ITEM: 6.14	COMMITTEE OF ADJUSTMENT REPORT SUMMARY MINOR VARIANCE APPLICATION FILE NUMBER A149/23 9929 KEELE STREET, VAUGHAN
-------------------	---

**COMMITTEE OF ADJUSTMENT REPORT
MINOR VARIANCE APPLICATION
A149/23
9929 KEELE STREET, VAUGHAN**

ITEM NUMBER: 6.14	CITY WARD #: 1
APPLICANT:	Sharewell Investments Inc.
AGENT:	Trinity Point Developments
PROPERTY:	9929 Keele Street, Vaughan
ZONING DESIGNATION:	See Below
VAUGHAN OFFICIAL PLAN (2010) DESIGNATION:	City of Vaughan Official Plan 2010 ('VOP 2010'): "Low-Rise Mixed-Use"
RELATED DEVELOPMENT APPLICATIONS:	DA.23.001
PURPOSE OF APPLICATION:	Relief from the Zoning By-law is being requested to permit a mixed-use development consisting of a 4-storey building with a total of 110 apartment units and a ground floor commercial area. Relief is also required to facilitate related Site Plan Application DA.23.001.

Requested Variance- 4 Reference: Drawing A301 pg 4

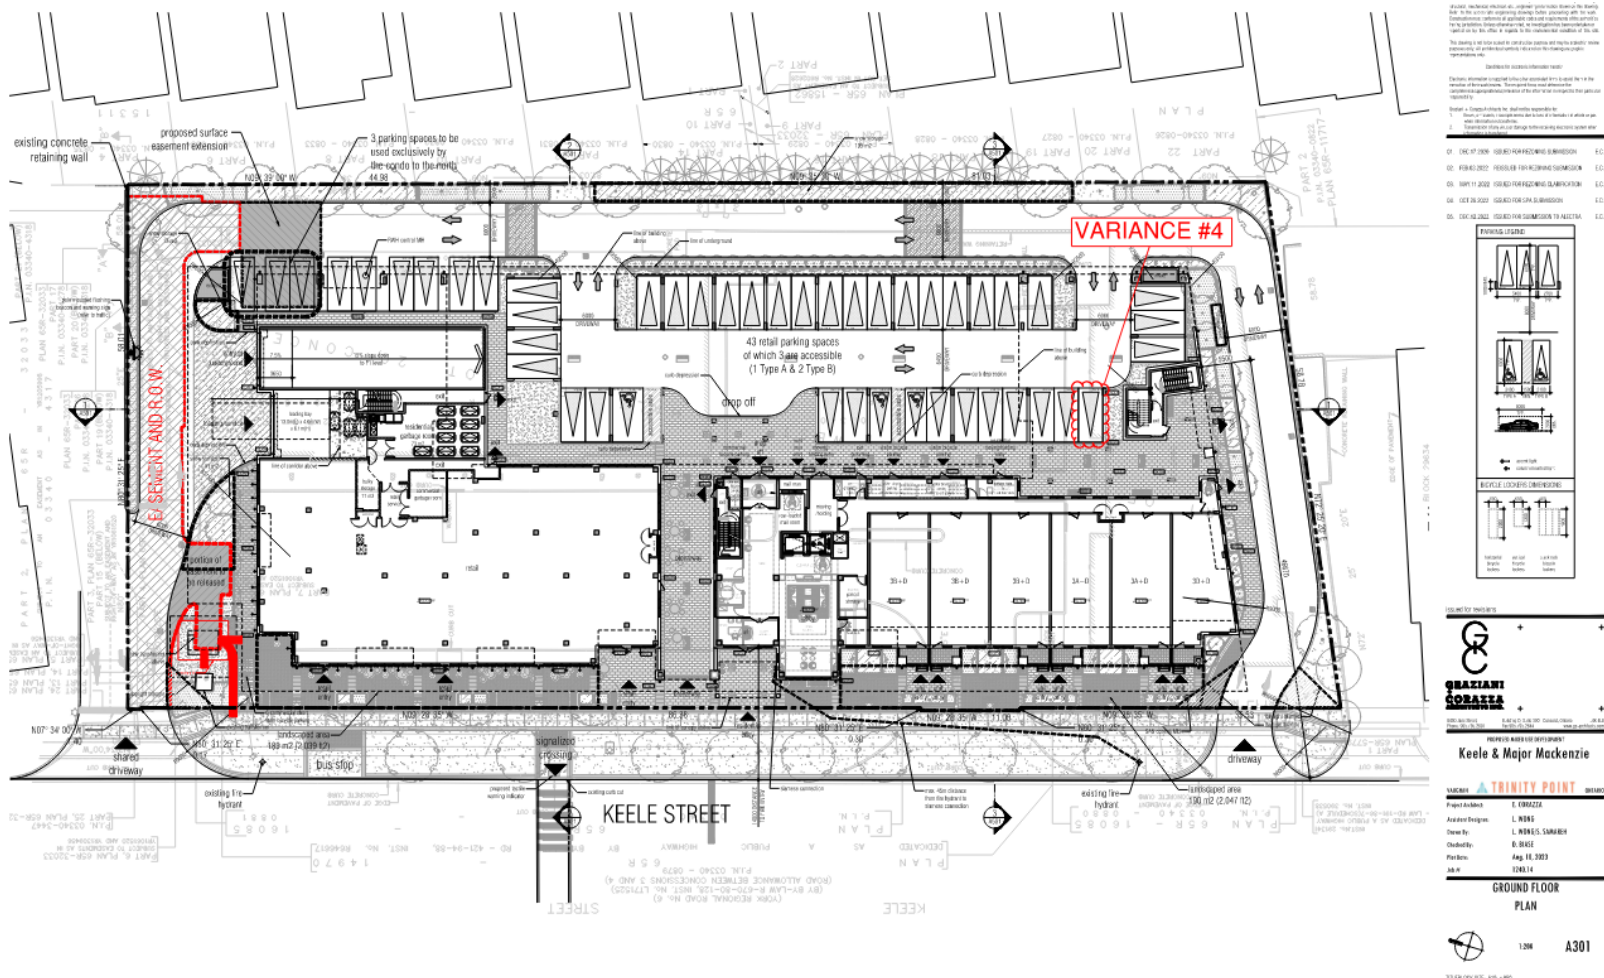
The Development Planning Department has no objection to Variance 4 for the reduction in visitor parking spaces in the at grade parking area as it is not being removed, but relocated within the underground parking level. The single at-grade residential visitor parking space is proposed to be consolidated with all the residential visitor parking spaces in the underground parking garage in order to maximize the at-grade commercial and retail parking. This results in a total of 137 parking spaces below grade, 114 of which are residential spaces, and 23 of which are residential visitor spaces. Enhanced visitor parking functionality is anticipated as a result of this modification.

Requested Variance- 2 Reference: Drawing A302 pg 5

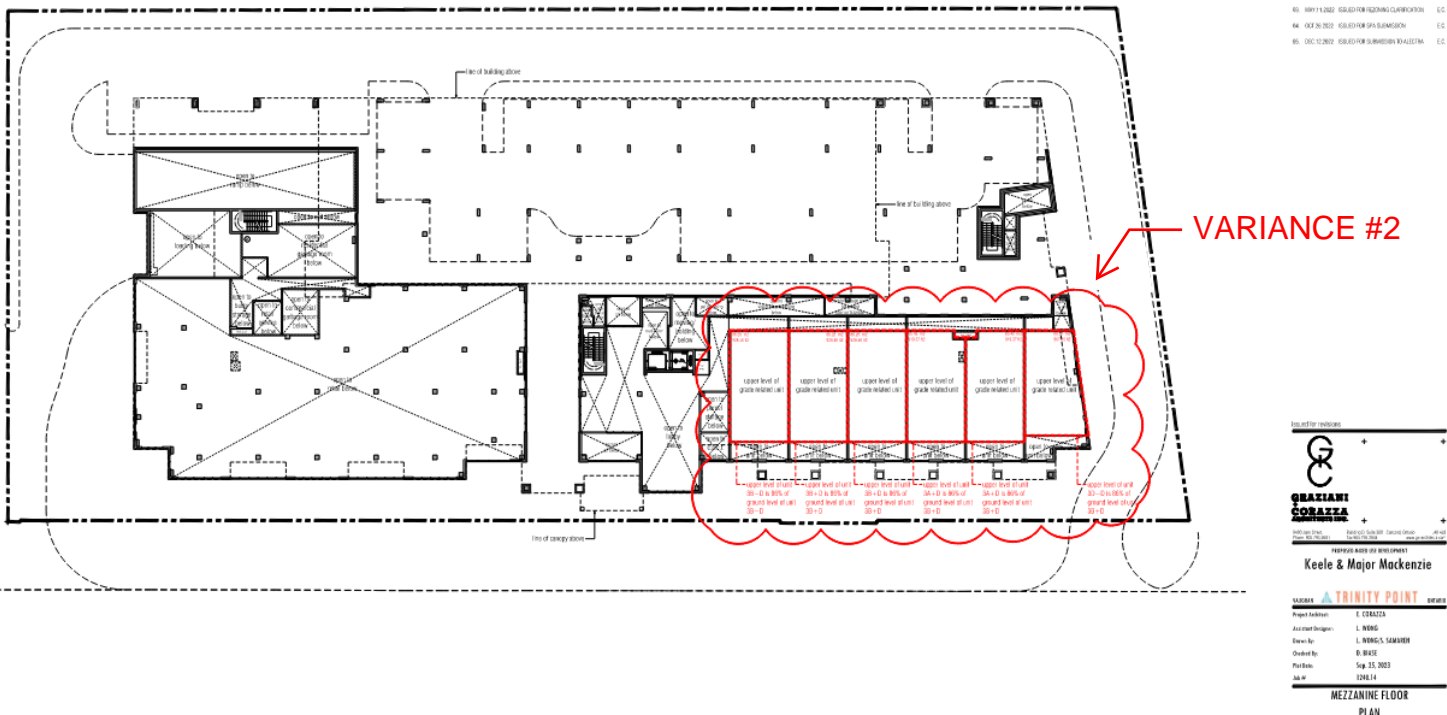
The Development Planning Department has no objection to Variances 2 and 3 as the increased height does not add an additional level to the building. The ground floor has an exceptionally high ceiling to provide for the commercial uses at the north end of that storey and to hide the necessary mechanical systems that would otherwise drop down from the floors above within visual bulkheads. In light of the generous ground floor ceiling height, the Owner proposes to add second floors to the residential units on the ground floor to make better use of the space and provide them with more floor area. This will result in larger units and accommodate larger households. Adding a second level to the ground floor units causes the level to be classified as a storey.

The second level of each ground floor unit does not match the floor area of the first level; it is limited to 86% of the ground floor's gross floor area. Each unit's second level can only be accessed from the first floor of each respective unit. No common corridor or elevator stop is proposed to provide direct access from the building's common areas to the second level of the ground floor units. The exterior appearance of the building will not change with the introduction of a second floor to the ground floor units as no balconies are proposed that would identify a second floor and the window design (tall glass panels) will not change. As such, there is no revision to the built form from that which was approved by Council.

Requested Variance- 5 Reference: Drawing A401 pg 1 (Elevations Drawings)

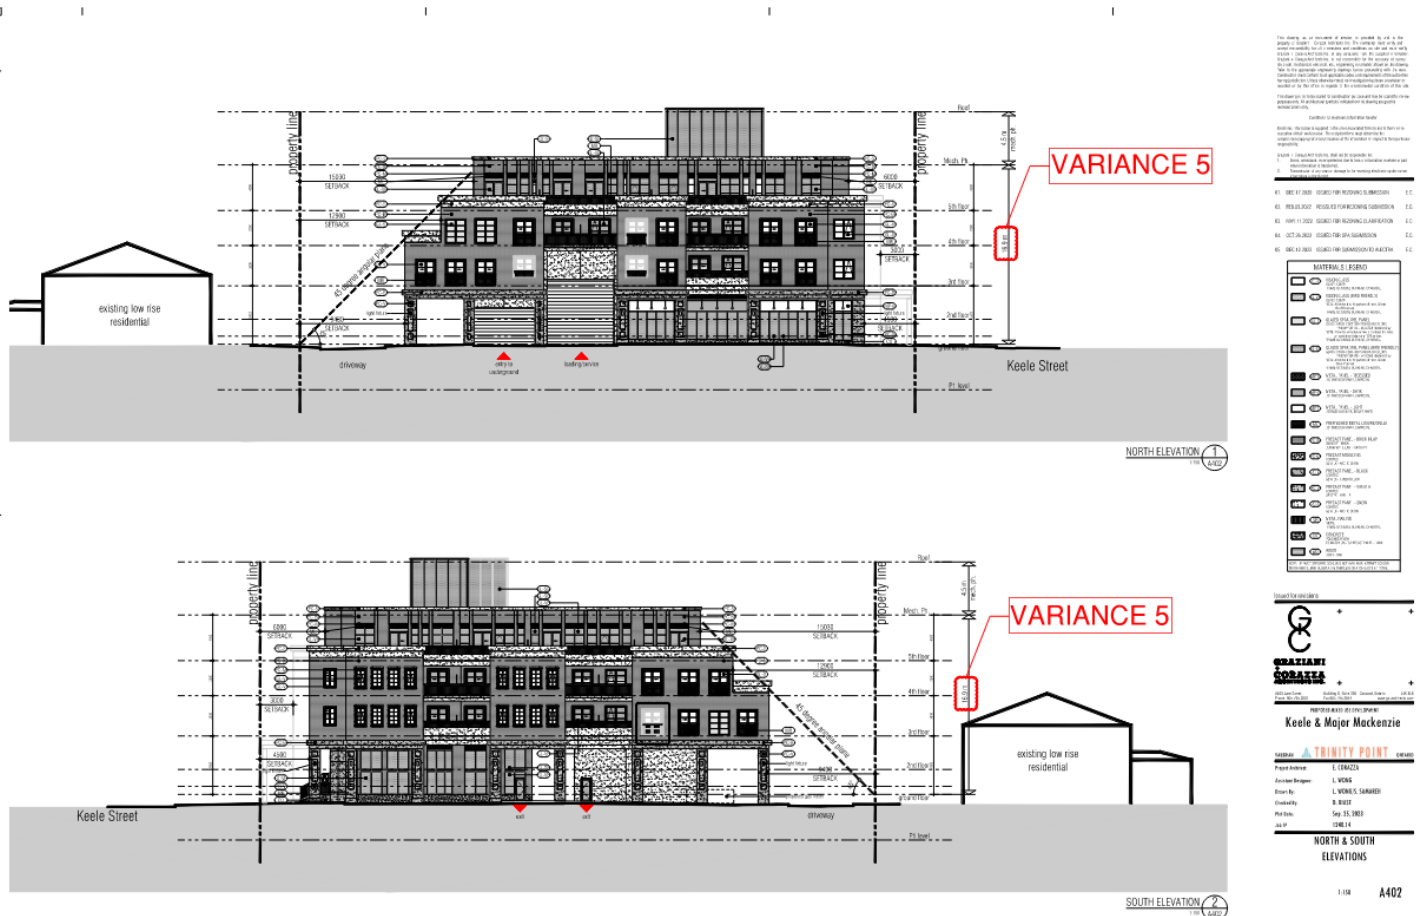
The Development Planning Department has no objection to Variance 5 for the increase in building height to the surface of the roof exclusive of the mechanical room. Due to artesian groundwater pressure under the site, thicker floor slabs are required to increase the building's weight in order to counterbalance the upward pressure of the artesian condition, resulting in unit ceiling heights that would otherwise be reduced without relief from the height requirement. The requested additional height would be distributed equally (0.3 m/floor) for floors 2, 3 and 4, resulting in the provision of more comfortable unit ceiling heights. In addition, the increased floor height permits the accommodation of the mechanical system and noise attenuation measures, while still maintaining appropriate ceiling heights.
